**Addendum Number 03  
(June 19, 2024)**

**EDINBURG CTE CENTER**

PBK Project No.: 20217

**ECISD Barrientes – Edinburg CTE Center  
Addendum #3**

PARTIAL NEW FOUNDATION PLAN - AREA B

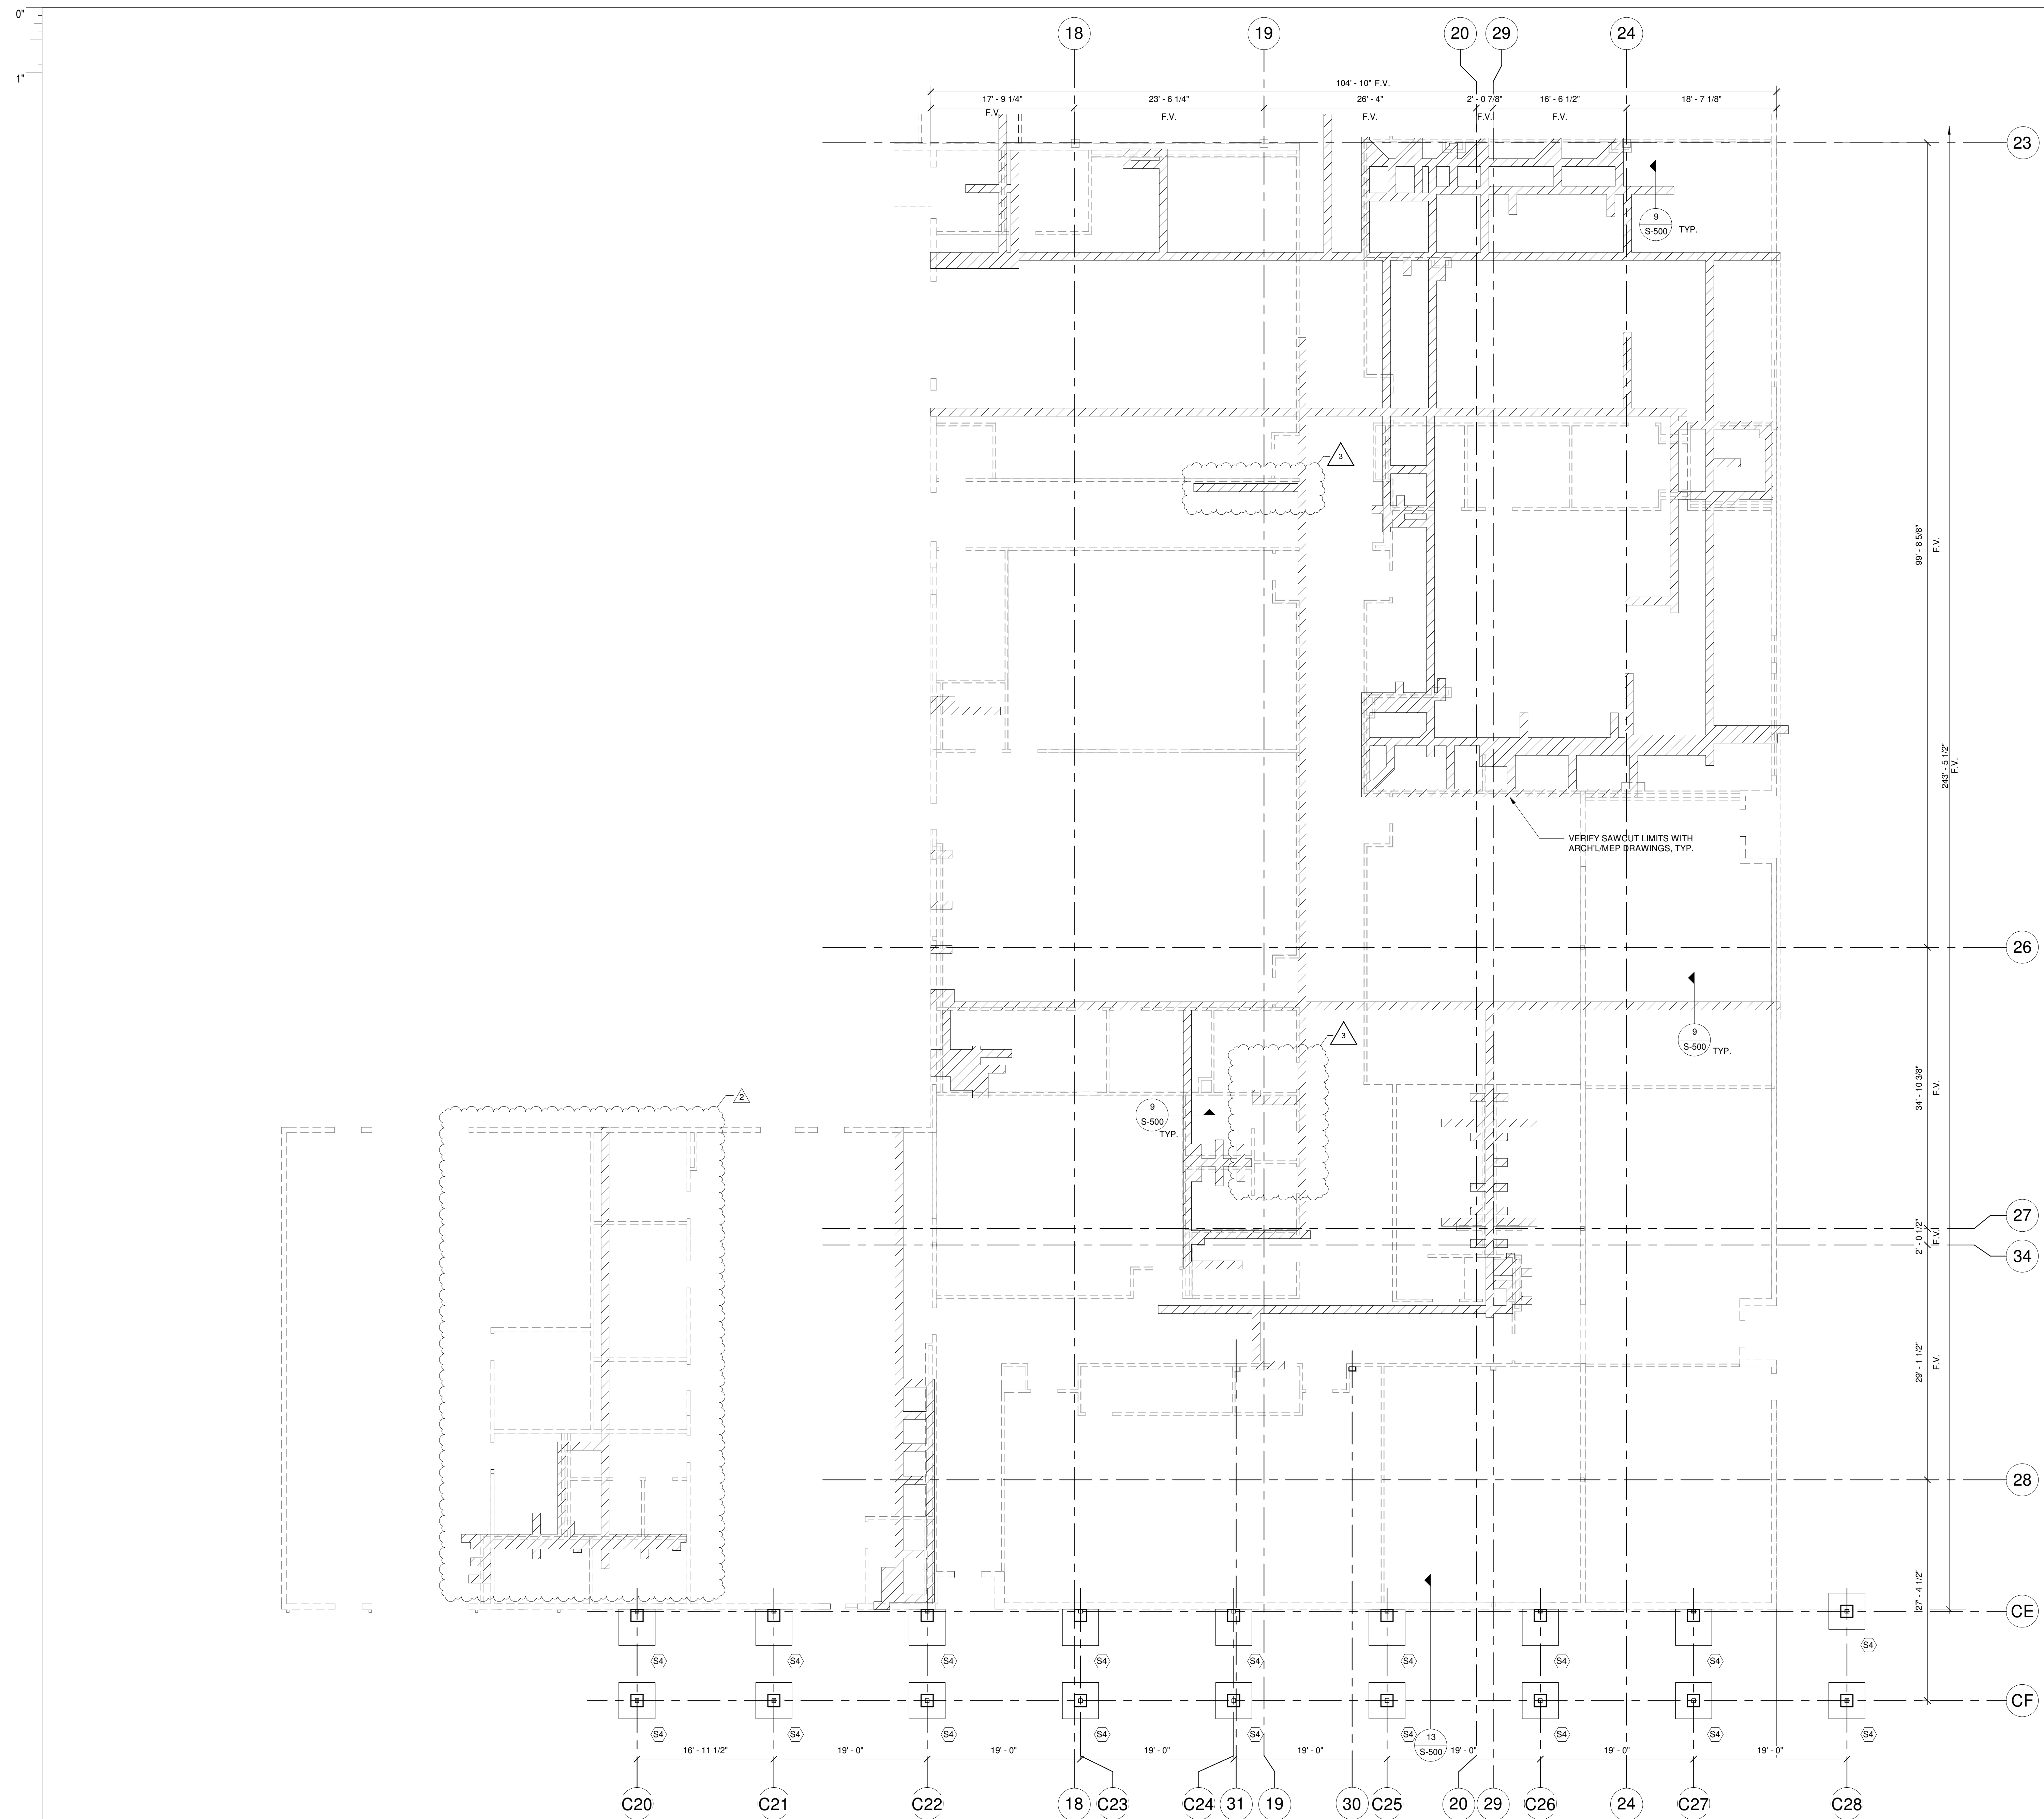
| 012 | S-202 – Partial New Foundation Plan – Area B   | Updated limit of sawcut trenches based on updated plumbing modifications. Delete in its entirety. Replace with revised Sheet S-202. Refer to attached.   |             |

- Updated limit of sawcut trenches based on updated plumbing modifications. Delete in its entirety. Replace with revised Sheet S-202. Refer to attached.

**OVERALL ROOF FRAMING PLAN**

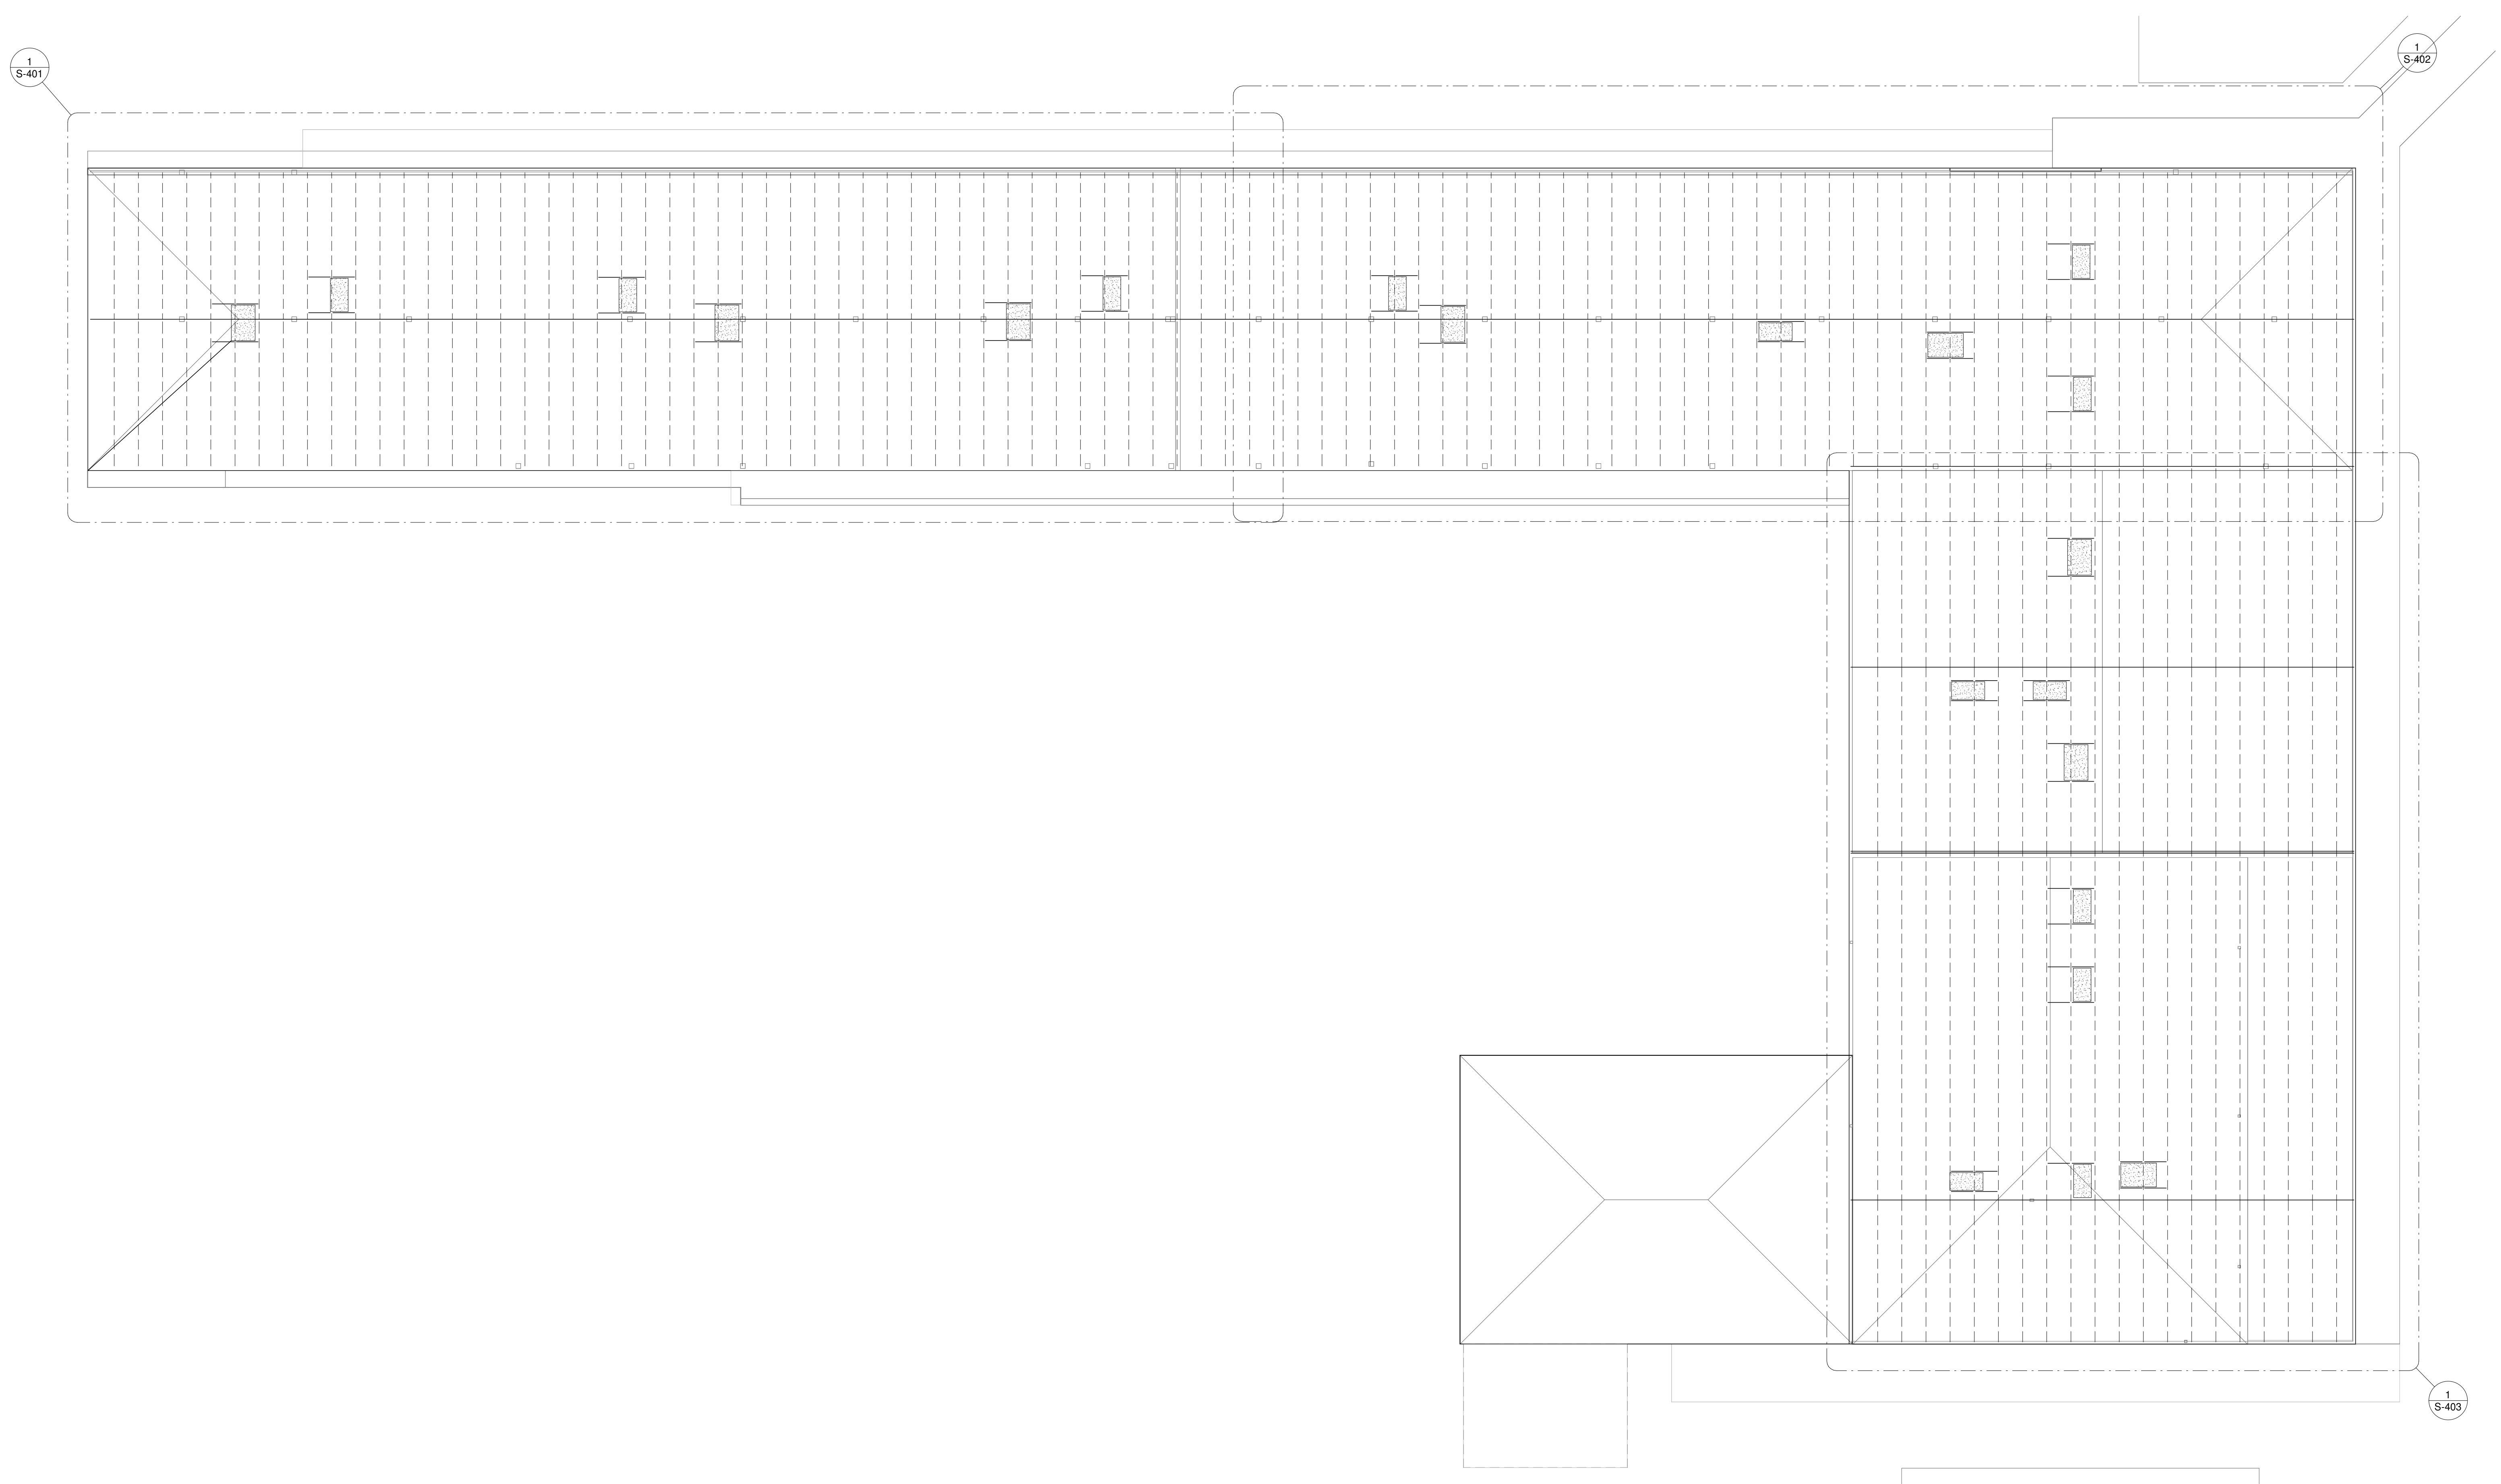
| 014 | S-400 – Overall New Foundation Plan  | Updated locations of mechanical roof top units. Delete in its entirety. Replace with revised Sheet S-400. Refer to attached.   |             |

- Updated locations of mechanical roof top units. Delete in its entirety. Replace with revised Sheet S-400. Refer to attached.

CHECKED BY: CC  
 DRAWN BY: VDV  
 Plot Stamp: 6/19/2024 4:23:59 PM  
 File Path: Autocad Docs/Edinburg CSD\_20215 ECISD Barrientes MS - CTE Renovations - R2 - Central\_vacillor.rvt  
 PARTIAL ROOF FRAMING PLAN - AREA A  
 FOR BLUEBEAM LABELING:OOR  
 S-401

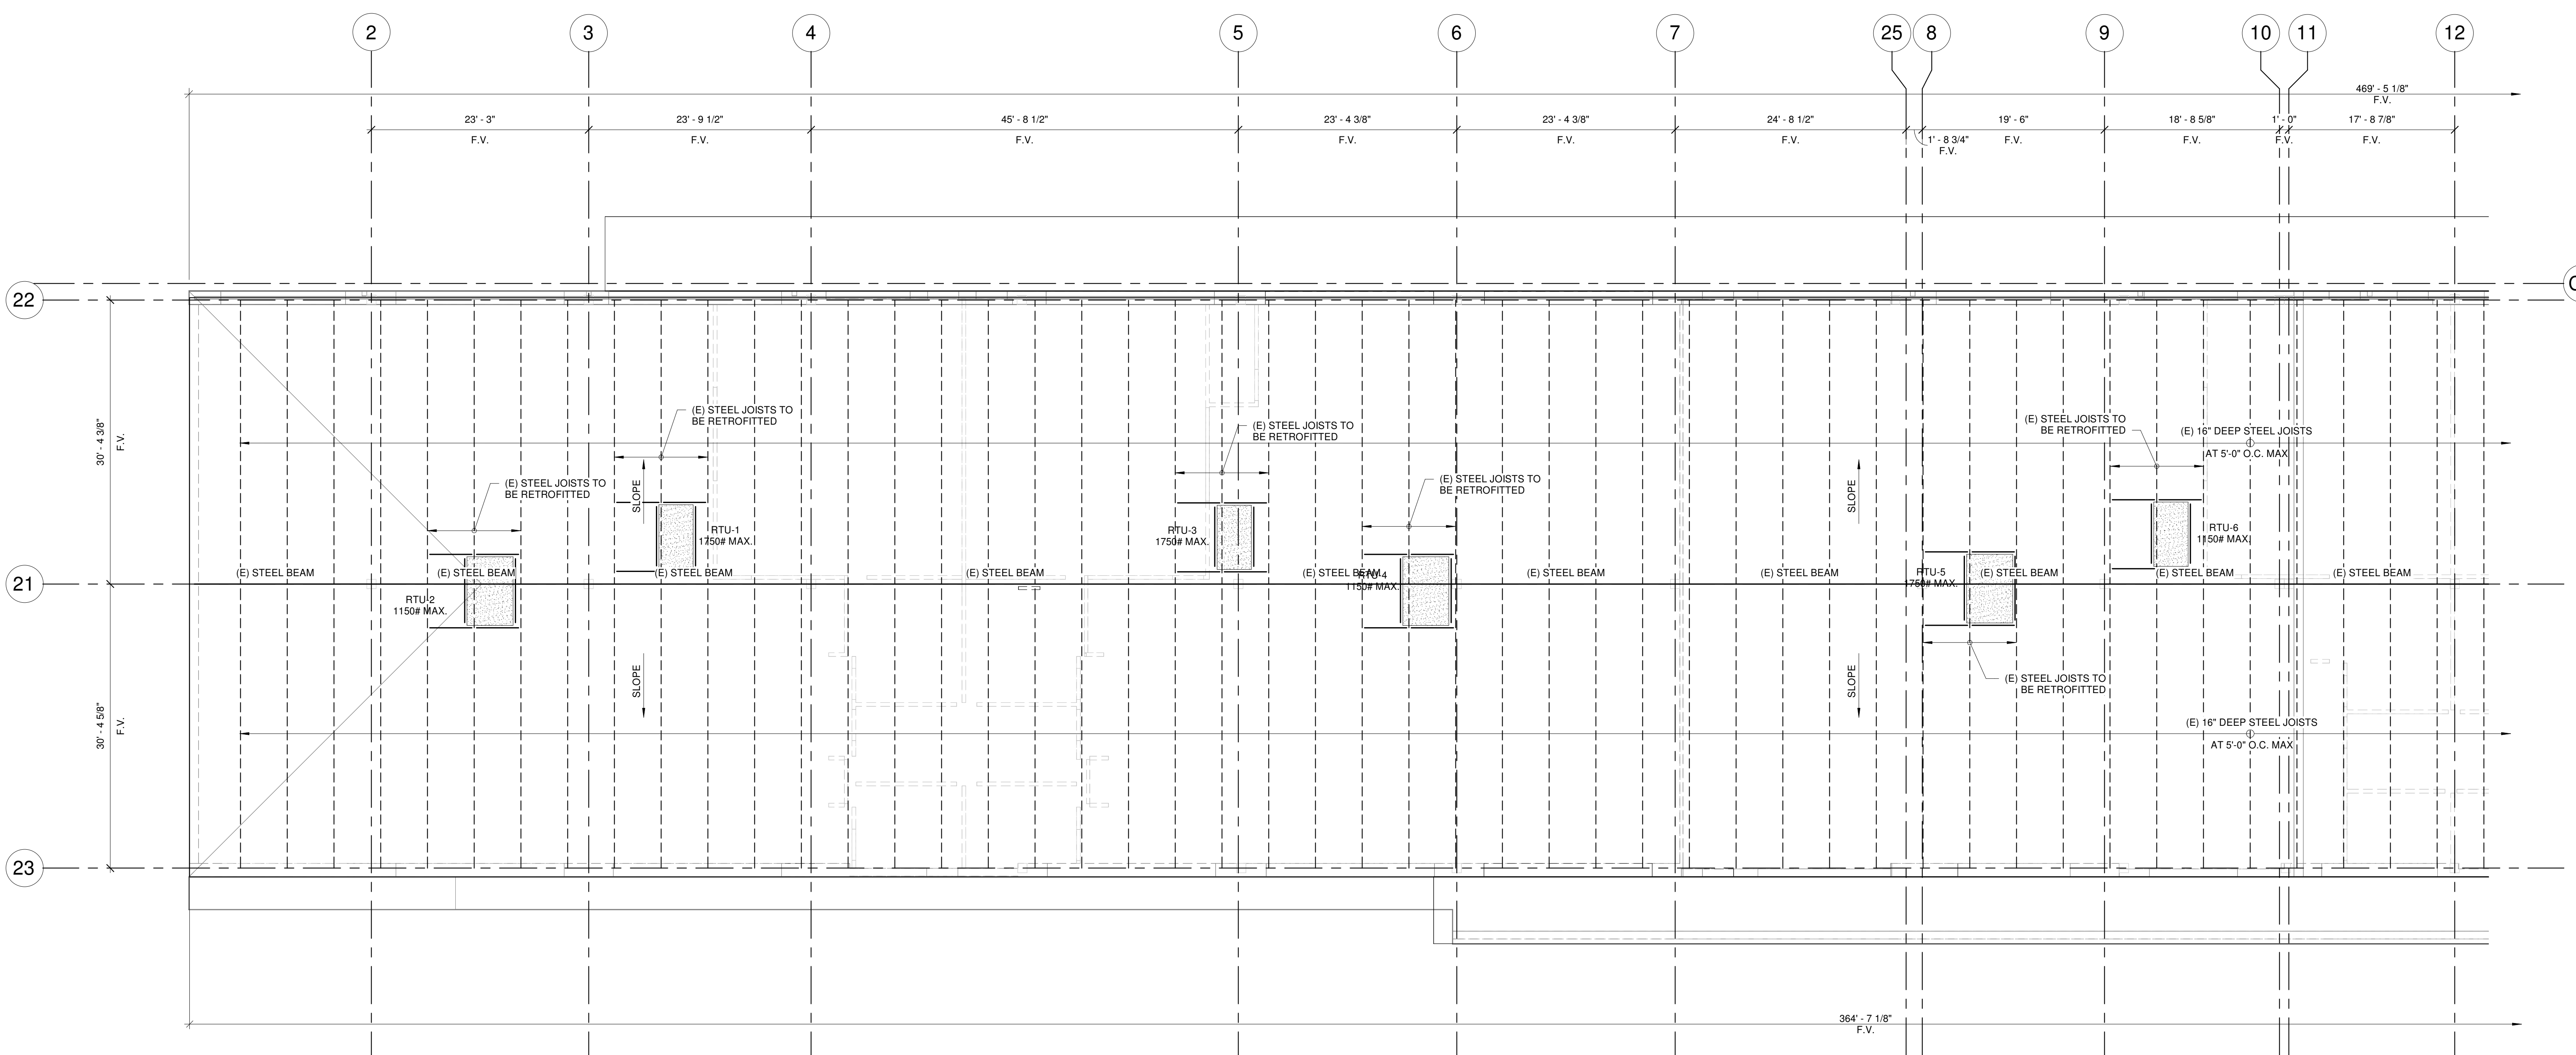
| 015 | S-401 – Partial New Foundation Plan – Area A   | Updated locations of mechanical roof top units. Delete in its entirety. Replace with revised Sheet S-401. Refer to attached.   |             |

- Updated locations of mechanical roof top units. Delete in its entirety. Replace with revised Sheet S-401. Refer to attached.
